# Access Compliance Report

## Public Rights-of-Way

### (Curb Ramps)

Intersection ID: 2932	Main Street: GREEN_HEDGE_AV	Cross Street: WINTER_PINE_LN	Location: NW
ADA ID: 85E234368DBD	Ramp Type: Perp	Initial Pass/Fail: Fail	Overall Compliance: No
			Severity Score: 21.25

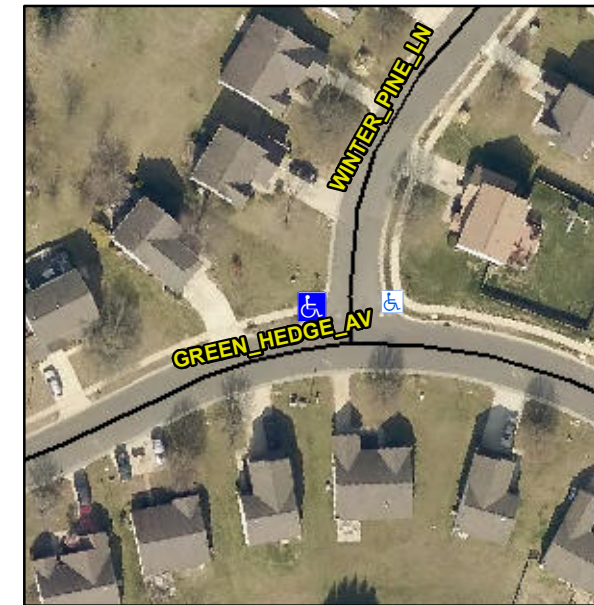
**Not Found, R304.5.1, R304.2.2**

Compliance	Description	Data	Compliance	Description	Data
N/A	Ramp Length (in)	49.0	No	Ramp Slope (%)	10.8
No	Ramp Width (in)	38.0	Yes	Ramp XSlope (%)	1.6
N/A	Flare Type LT	N/A	N/A	Flare Type RT	N/A
N/A	Flare Slope LT (%)	N/A	N/A	Flare Slope RT (%)	N/A
N/A	Flare Traversable LT?	N/A	N/A	Flare Traversable RT?	N/A
N/A	Landing Length (in)	N/A	N/A	DWS Provided?	N/A
N/A	Landing Width (in)	N/A	N/A	DWS Contrast?	N/A
N/A	Landing Slope (%)	N/A	N/A	DWS Length (in)	N/A
N/A	Landing X Slope (%)	N/A	N/A	DWS Full Width?	N/A
N/A	Landing Curb? (Y/N)	N/A	N/A	DWS Offset (in)	N/A
N/A	Shared Landing?	N/A			
N/A	Gutter Ponding?	N/A	N/A	Gutter Slope (%)	N/A
N/A	Gutter Lip Ht (in)	N/A	N/A	Gutter X Slope (%)	N/A
N/A	Painted X Walk1?	No	N/A	Painted X Walk2?	N/A
	X Walk 1 Direction	To E		X Walk 2 Direction	N/A
N/A	X Walk 1 Width (in)	N/A	N/A	X Walk 2 Width (in)	N/A
	X Walk 1 Slope (%)	0.5		X Walk 2 Slope (%)	N/A
	X Walk 1 X Slope (%)	0.0		X Walk 2 X Slope (%)	N/A

**Remove & Replace Entire Ramp.**
